Project: North Cove Cellular Steel Sheet Pile Encasement **Date:** 11/13/15

Engineer: McLaren Engineering Group **RE:** Addendum #2
of Pages: 9 pages

The following revisions and/or clarifications are to be made to the Request for Proposals for “North Cove Cellular Steel Sheet Pile Encasement.” They are a result of issues discussed at the pre-proposal conference held on October 28, 2015, inquiries made by prospective proposers and additional requirements imposed by BPCA.

30' 15' 0' 30' FEET
SCALE: 1" = 30'

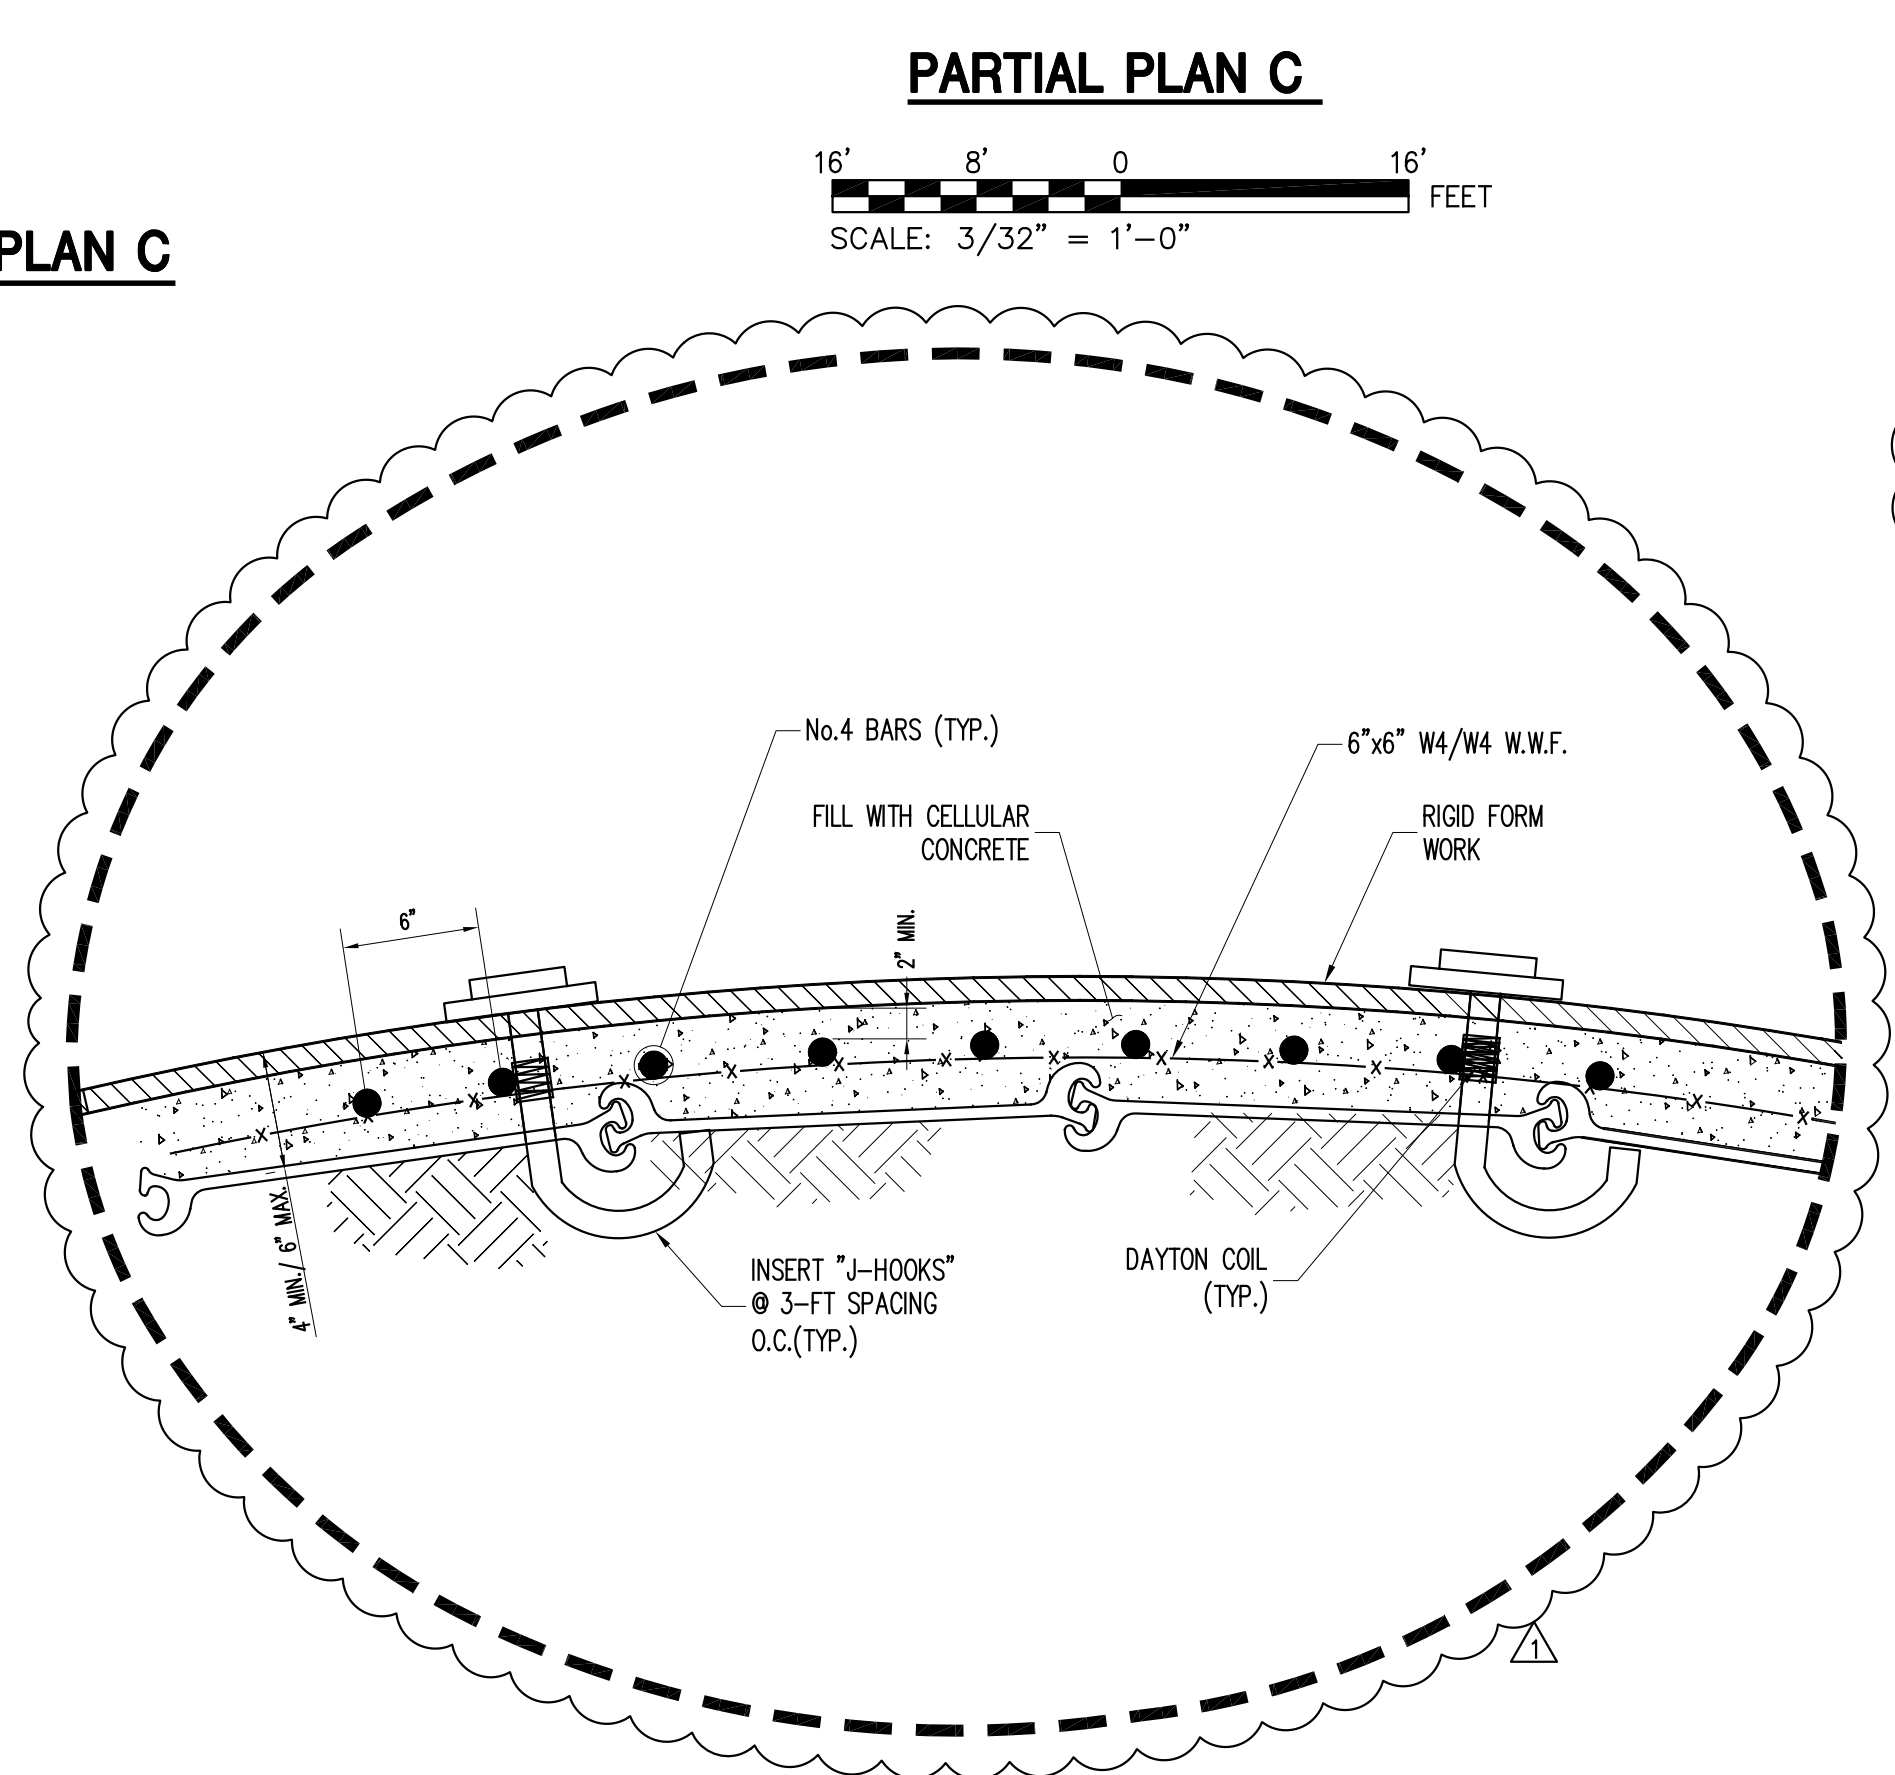
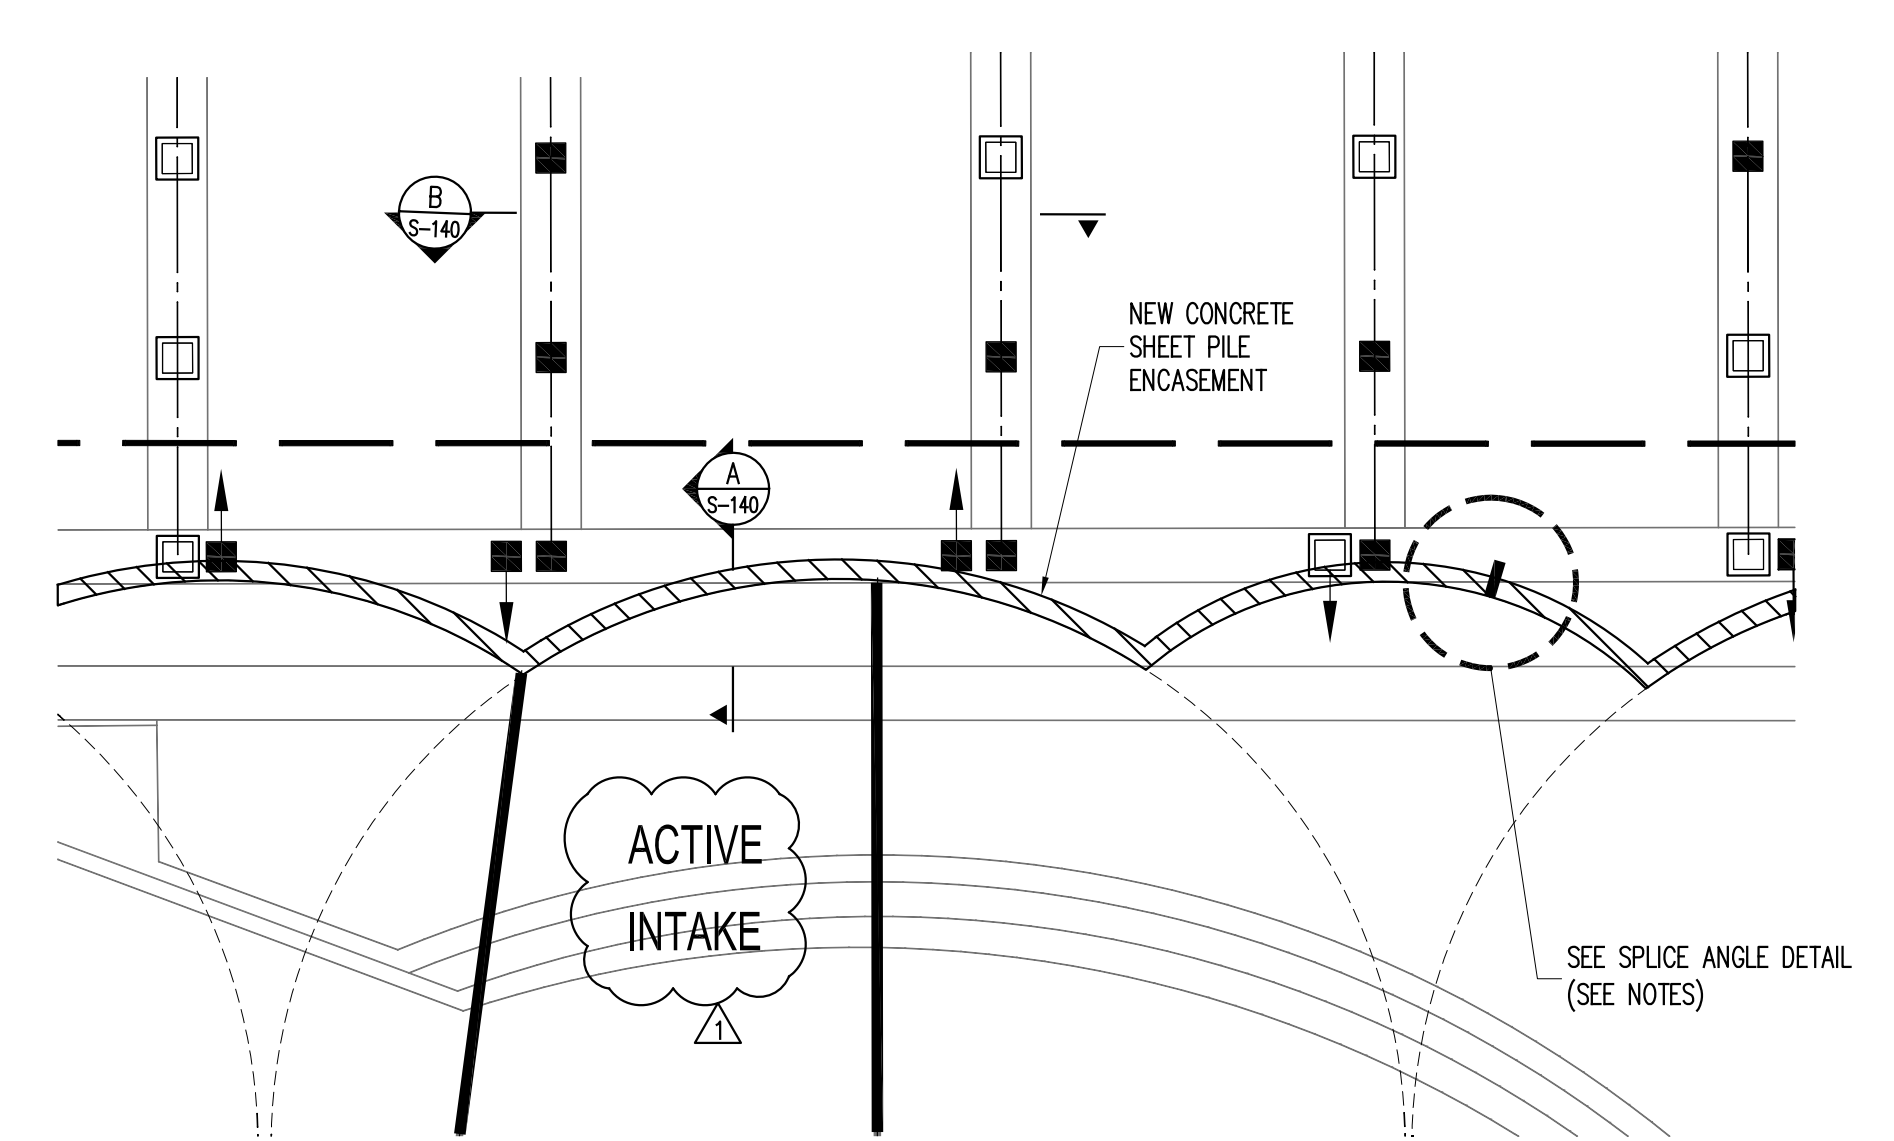
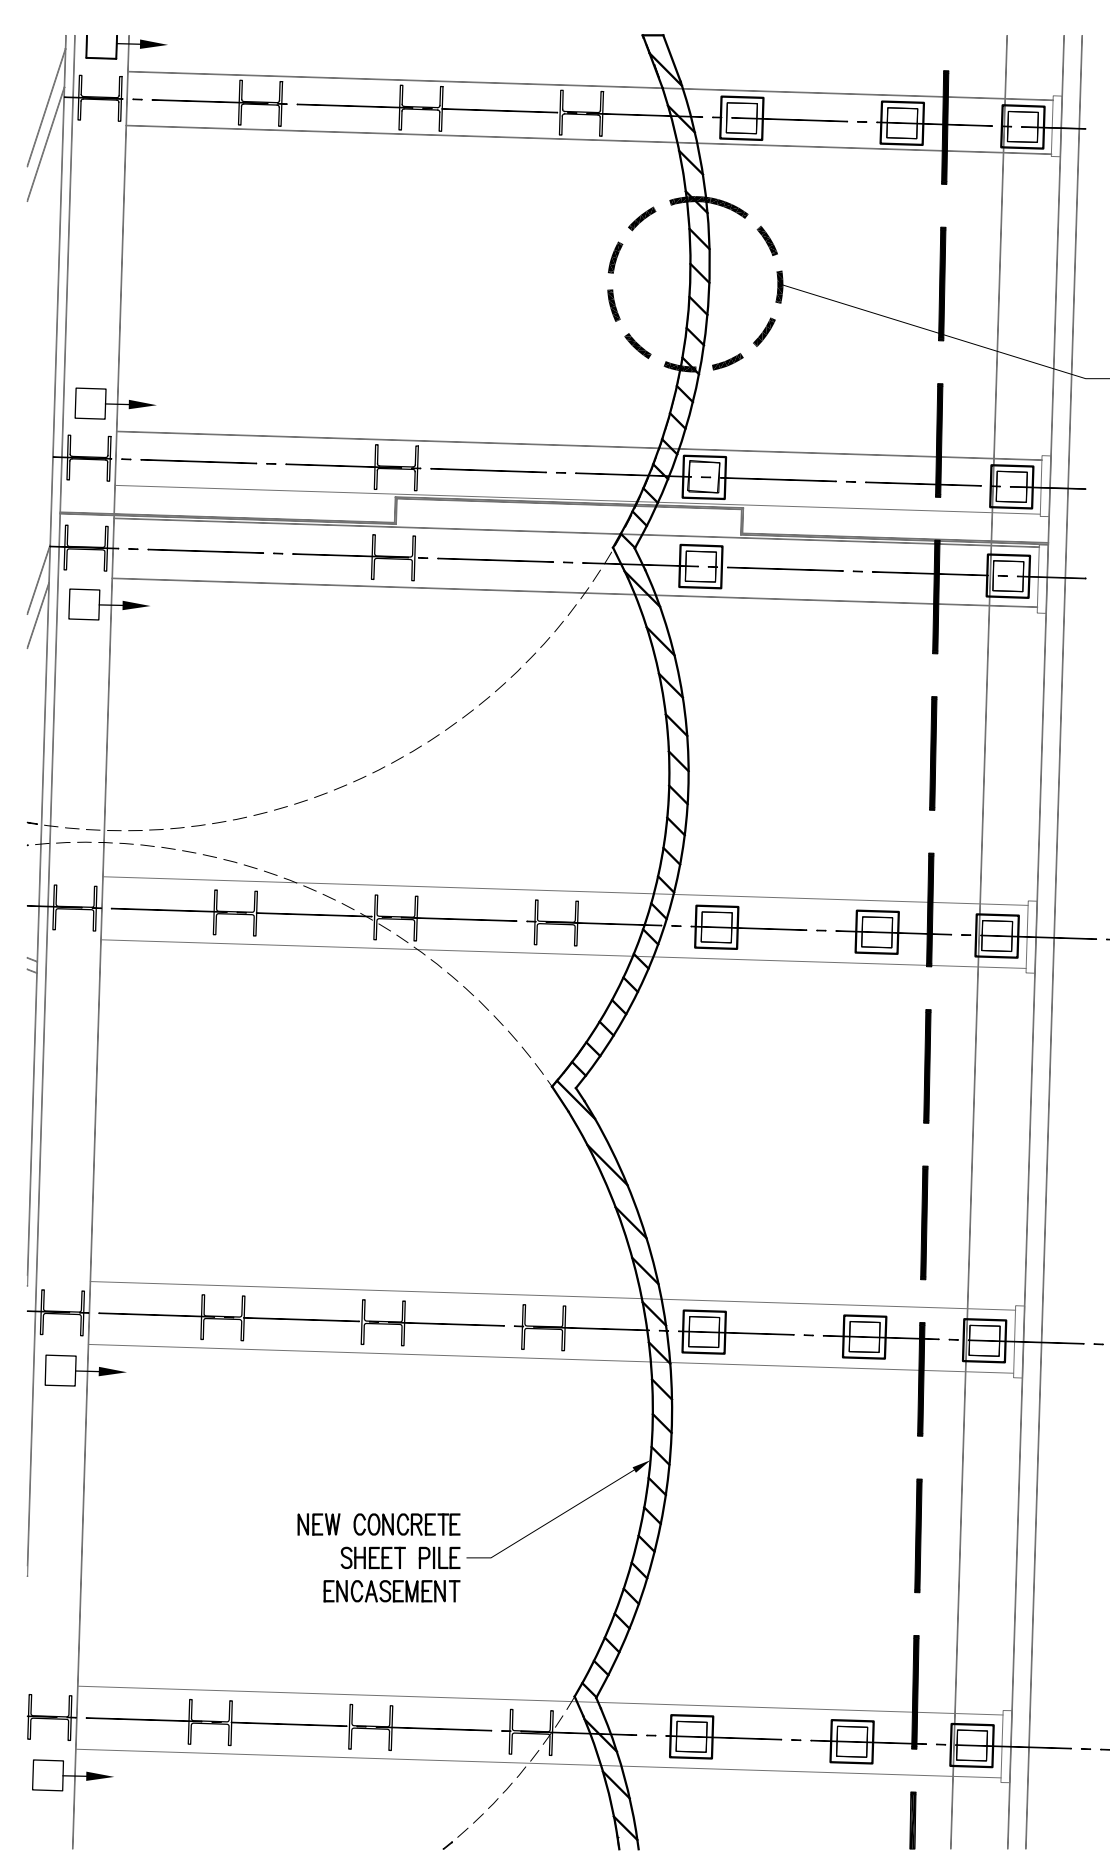
1 - Repair plan on S-132 refers to a continuation on S-133. This drawing is missing.

2 - Section C on S-140. Where is this section taken from?

4 - Section F and G on S-140 refer to Detail A on S-132. There is no detail A on S-132.

The scope of work terminates at Bent 107 inside the Path Tunnel, therefore, Drawing S-133 is not necessary for this bid. Please disregard that continuation sheet.

C/S-140 is taken from a cross section on Partial Plan C, Sheet S-132 as corrected in the drawings Revision No. 1 (attached).

See response to Question 2.
